**Site Location of Development**  
**TECHNICAL REVIEW MEMORANDUM**  
*Bureau of Land and Water Quality*

TO: **Donald Murphy, Project Manager, LURC**  
FROM: **David A. Waddell -- Division of Watershed Management** i  
DATE: **May 5, 2011**  
RE: **T16MD – Bull Hill Wind Project**

RE: Applicant Response to IF&W Review Comments - T16MD Bull Hill Wind Project DP#4886

*APPLICANT RESPONSE (ITALICS) TO IFW VERNAL POOL EMAIL COMMENTS  
OF MAY 12, 2011  
MAY 16, 2011*

Bull Hill SVP Impacts  
195600500  
4/28/2011

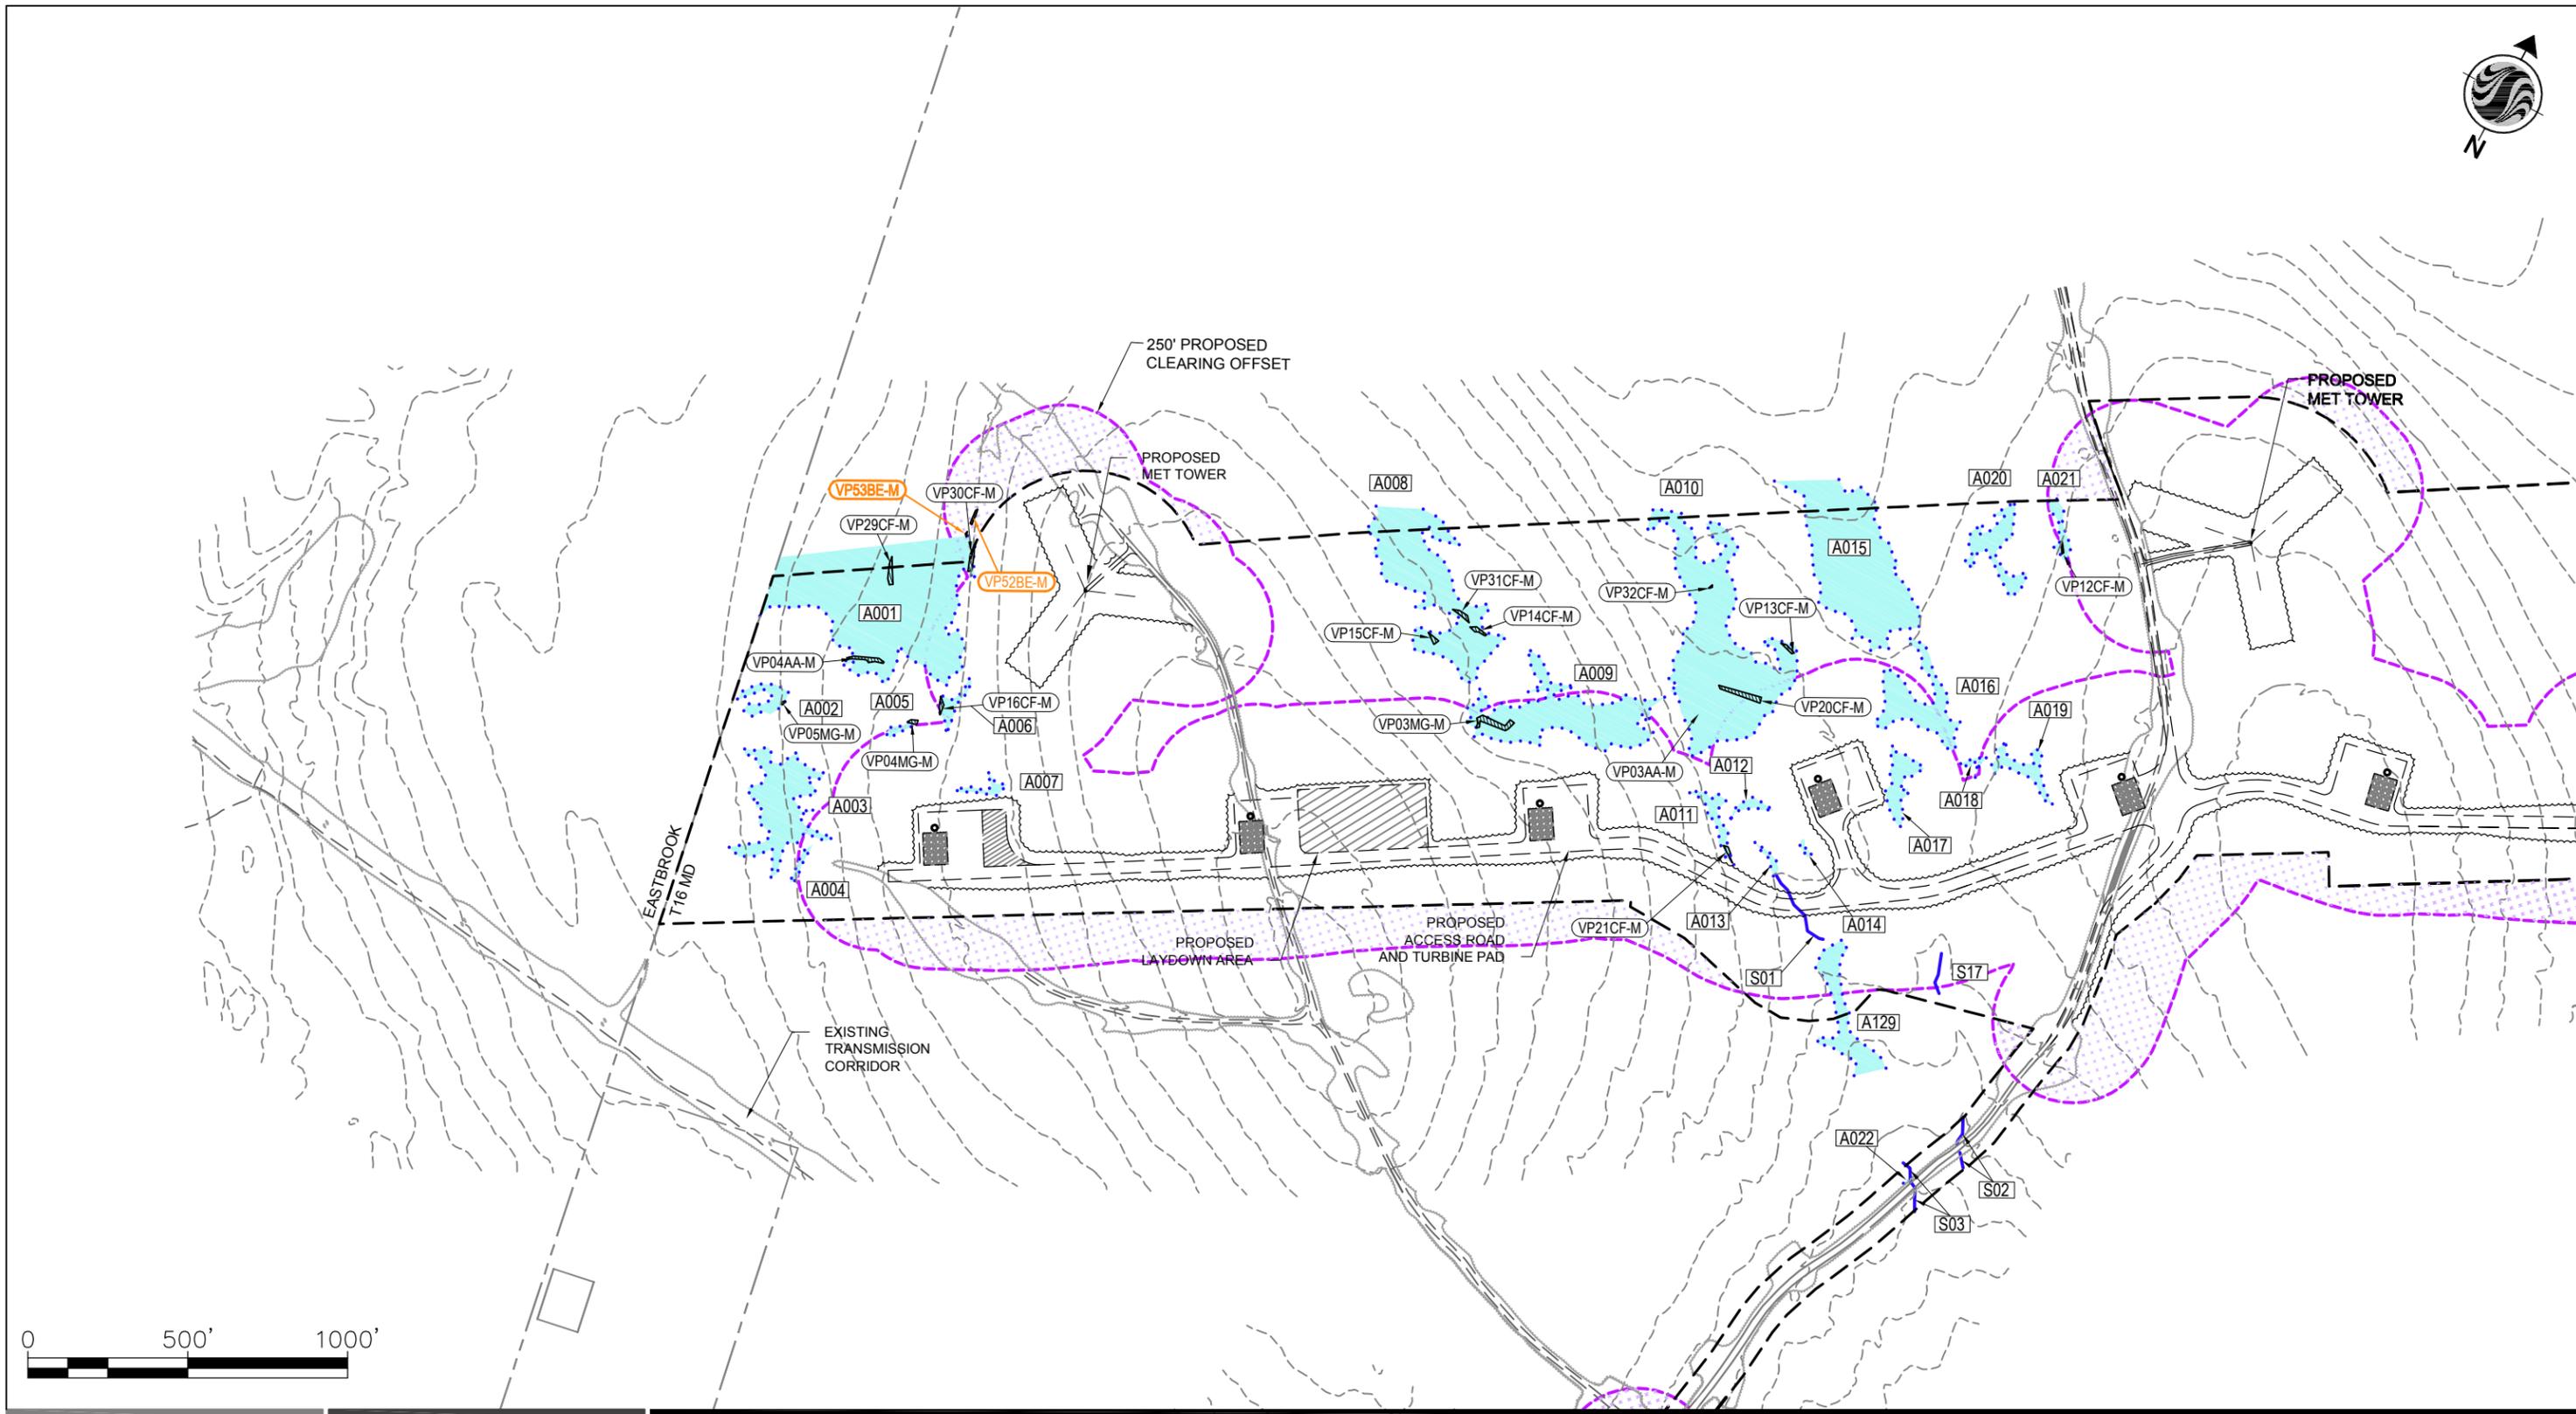
3. SVP 34CF: Post-project percent impact (39%) exceeds the 25% non-forested threshold for protecting significant vernal pools within the 250’ upland habitat zone. If the additional 14% impact can not be avoided or further minimized, MDIFW recommends project compensation for Significant Wildlife Habitat impacts.

*The 39% impact to the 250-foot upland habitat zone is an existing impact and is not an impact associated with the project. As noted above, the applicant’s use of the existing road does not involve any new clearing or disturbance and, importantly, does not result in a loss of functions or values of the resource. Therefore, we do not believe there is a regulatory, policy or environmental basis for requesting mitigation for the pre-existing impacts. Moreover, doing so would create a perverse incentive for applicants to construct new roads with attendant clearing and other potential habitat impacts, instead of using existing roads.*

Client/Project  
**Blue Sky East Wind, LLC**  
 Bull Hill  
 Eastbrook and T16MD, Maine  
 Figure No.  
**1**  
 Title  
**Delineated Natural Resource Map**  
 December 2010  
 rev. May 9, 2011

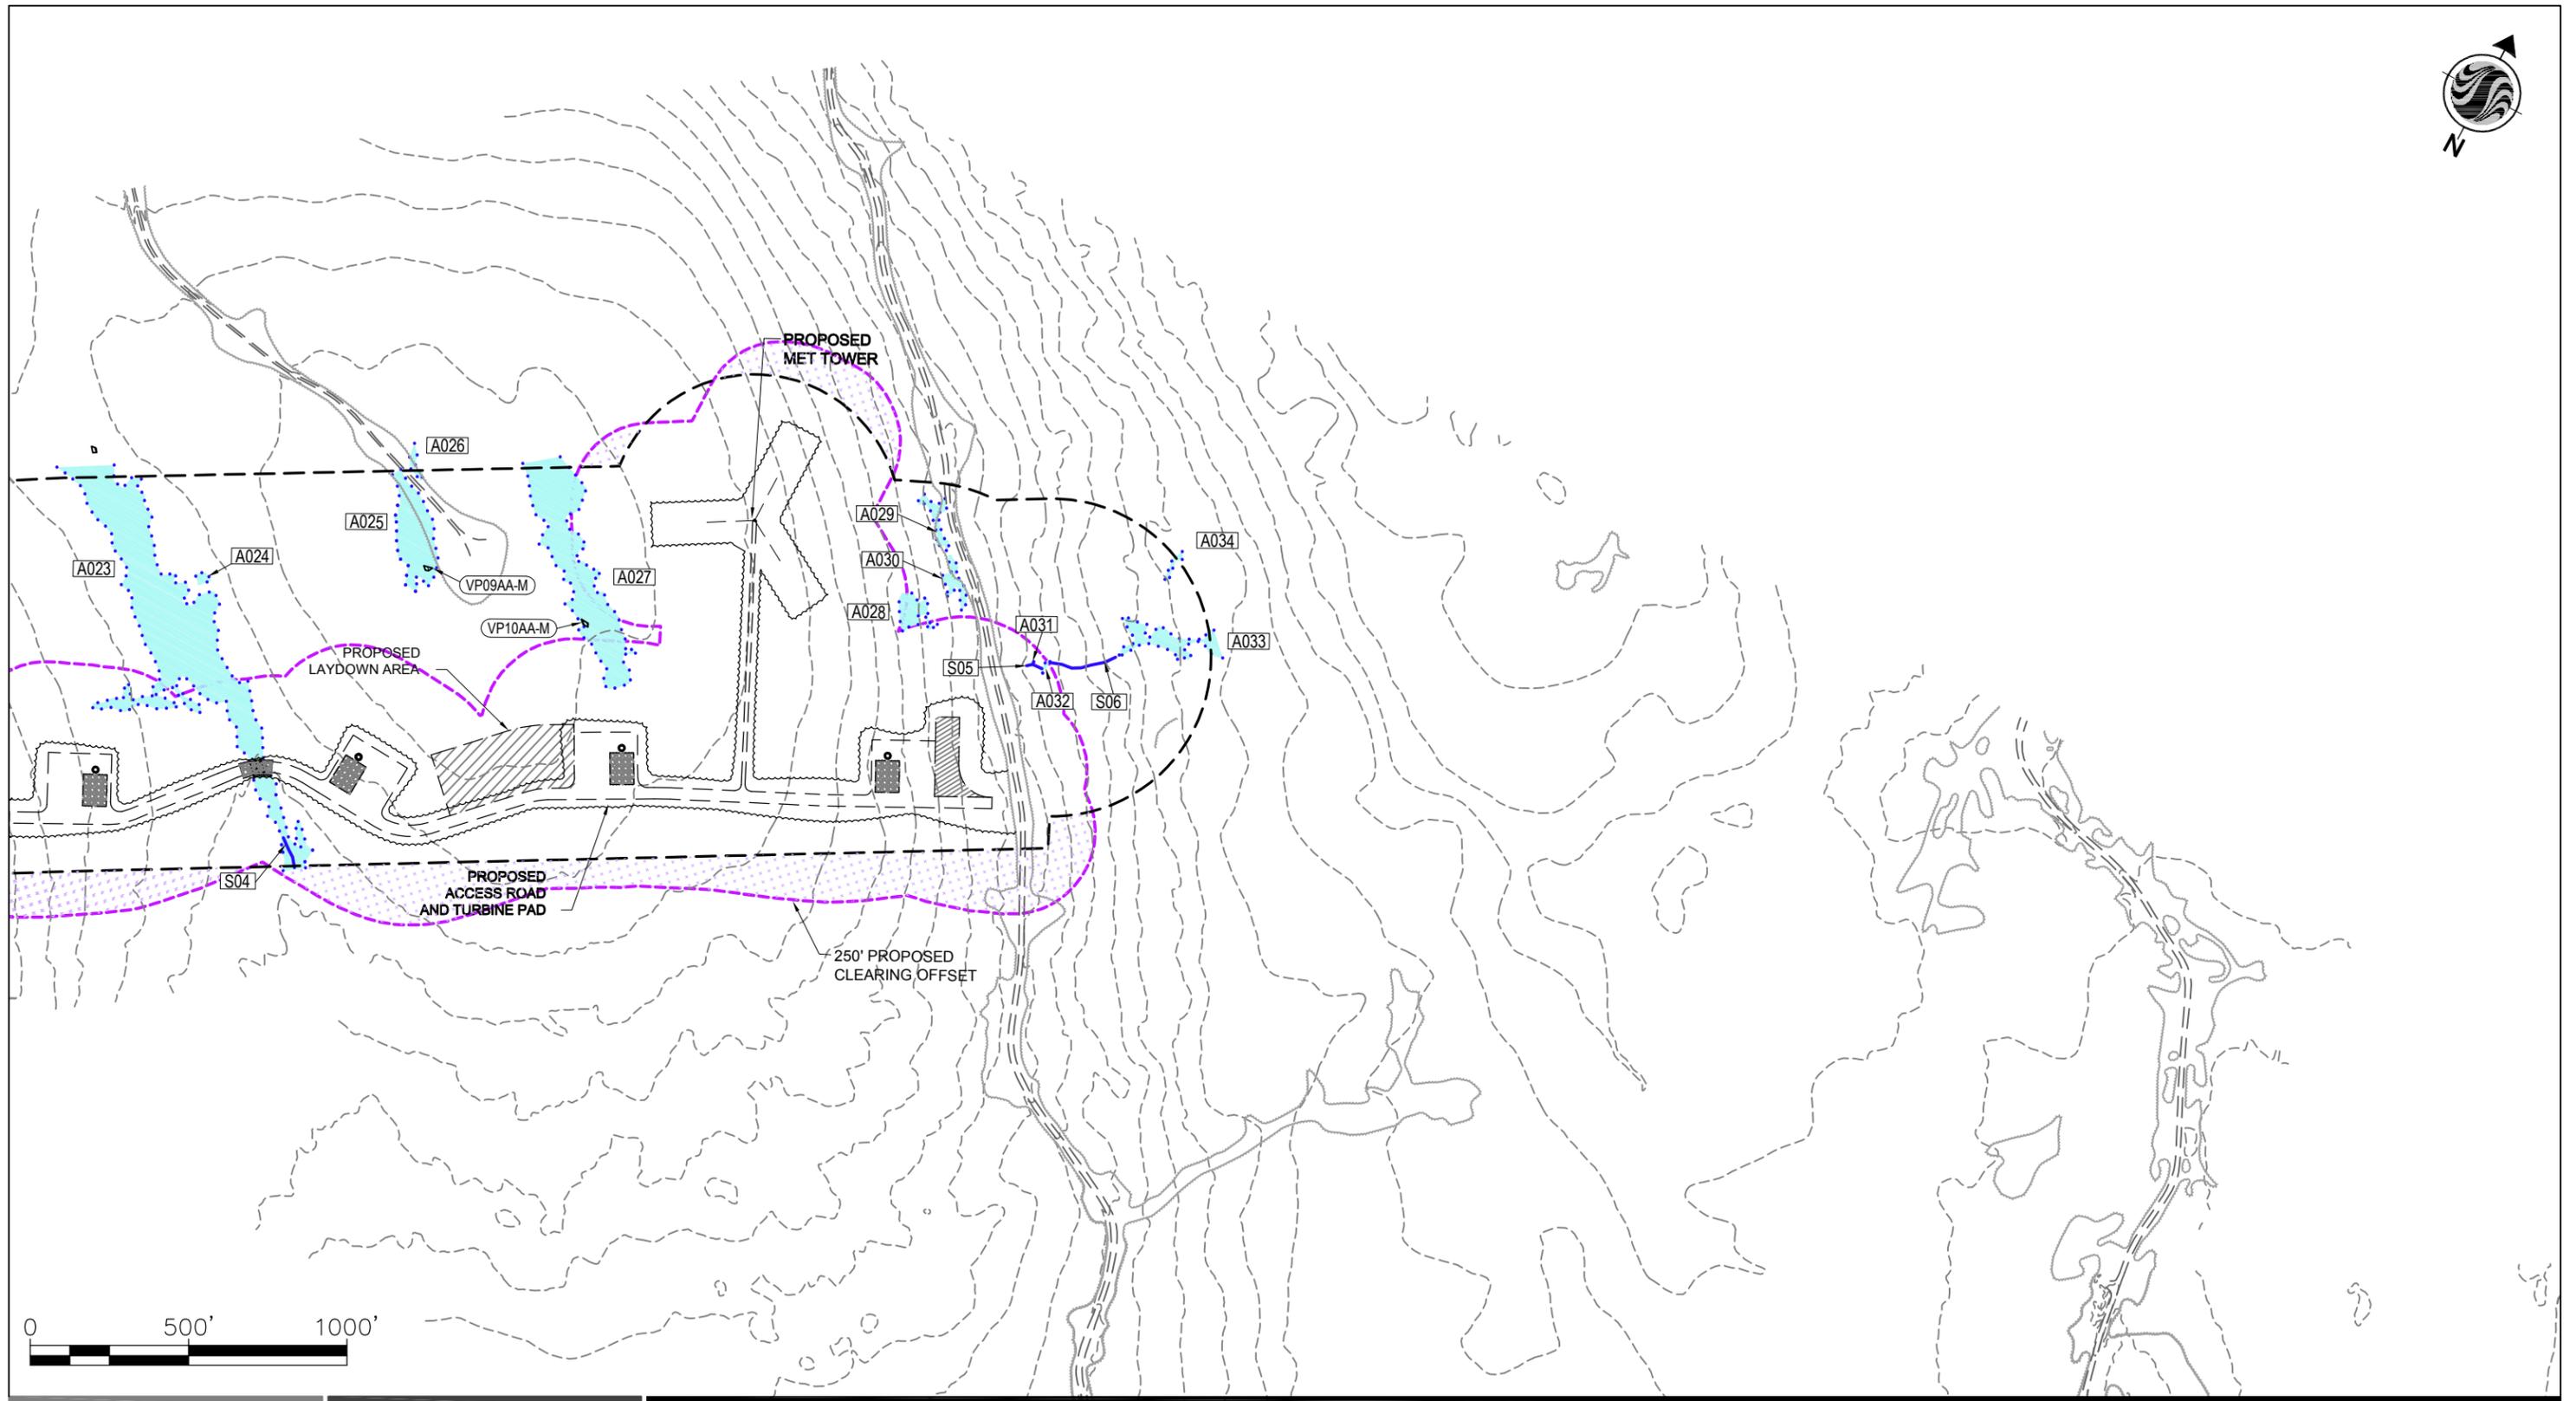
Without additional information from the applicant, MDIFW is unable to complete its review of potential project impacts to vernal pools or other wildlife resources. As currently defined, the project boundary does not sufficiently buffer the outside edge of existing or proposed development impacts to ensure that all resources of concern within 250' of a project activity are considered in the review.

*All areas within 250 feet of any project clearing were surveyed subsequently to receiving this comment verbally from IFW. Three man-made vernal pools and one natural pool were identified (see attached figures 1, 3, and 4). None met the level of significance. The vernal pool form for the natural pool is attached.*
